Amendments to the Drawings:

Attachment: Replacement Sheet

Fig. 1

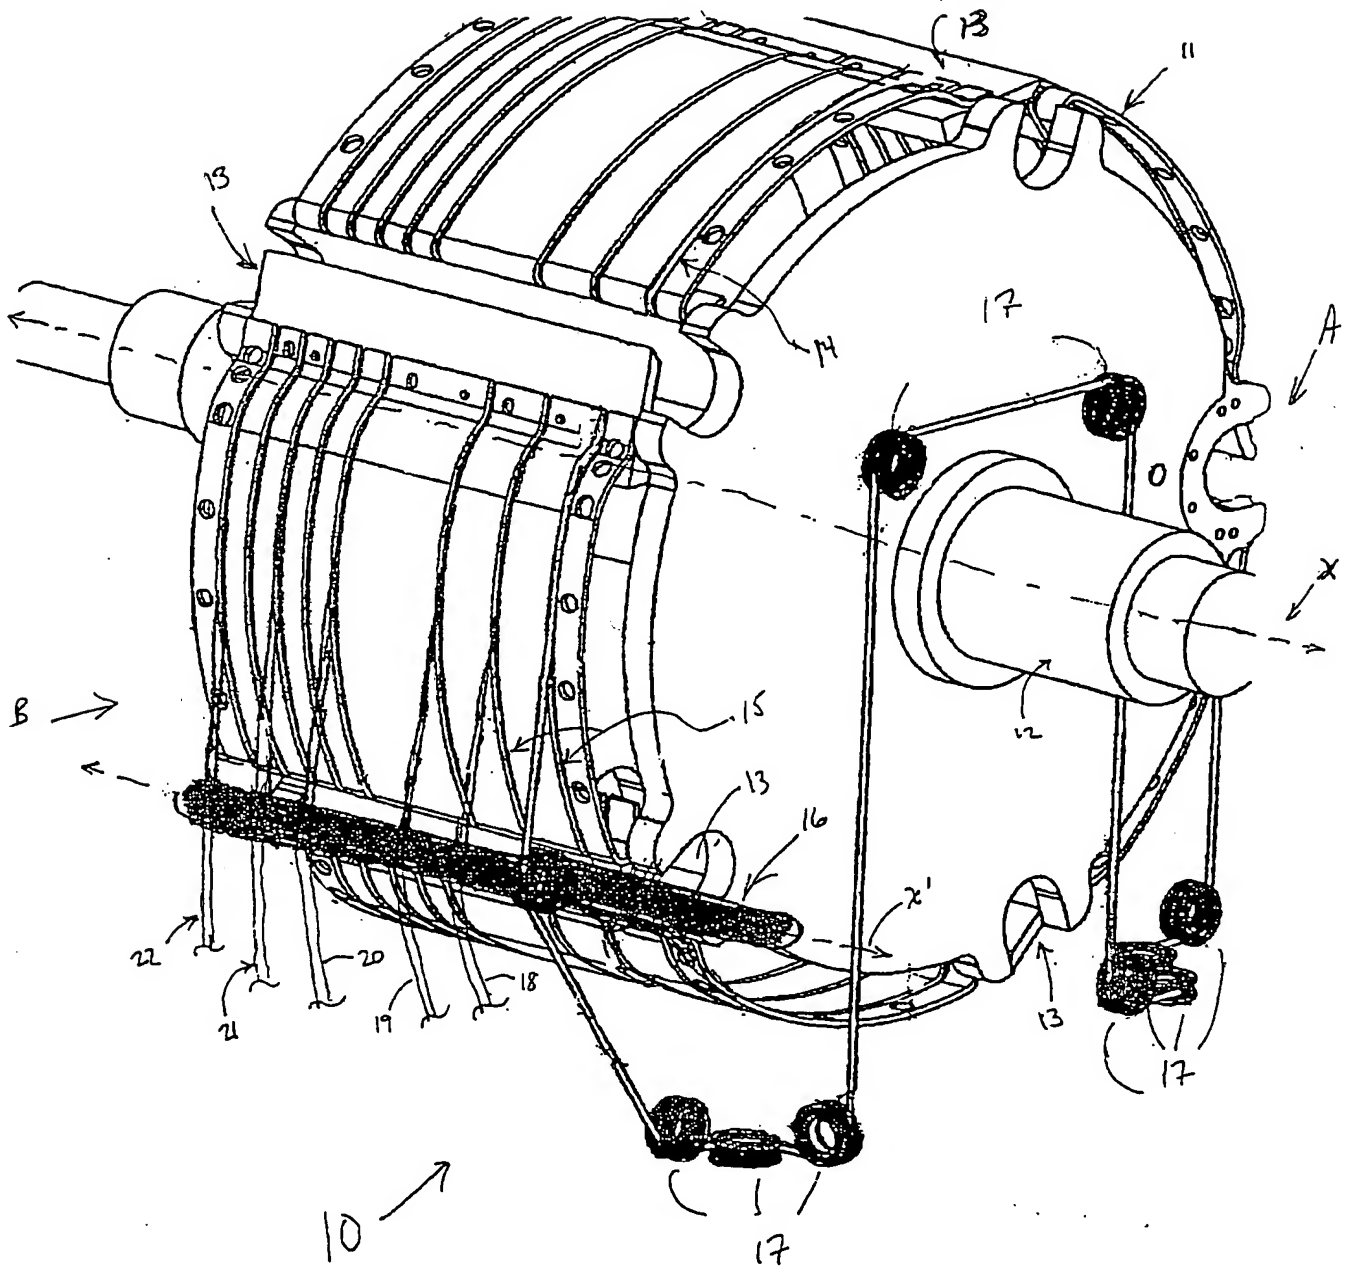
The attached sheet of drawings includes changes to Fig. 1. The attached sheet replaces the original sheet including Fig. 1. In Fig. 1, portions of the stripper belt in the regions of grippers 13 have been deleted to indicate that the path of the stripper belt passes beneath the grippers 13. In addition, previously omitted reference numbers 18-22, pointing to additional stripper belts, have been added. Finally, the stripper belts 18-22 have been extended beyond stripper roller 16 so as to more clearly indicate that only a portion of the additional stripper belts 18-22 is being shown in Fig. 1.
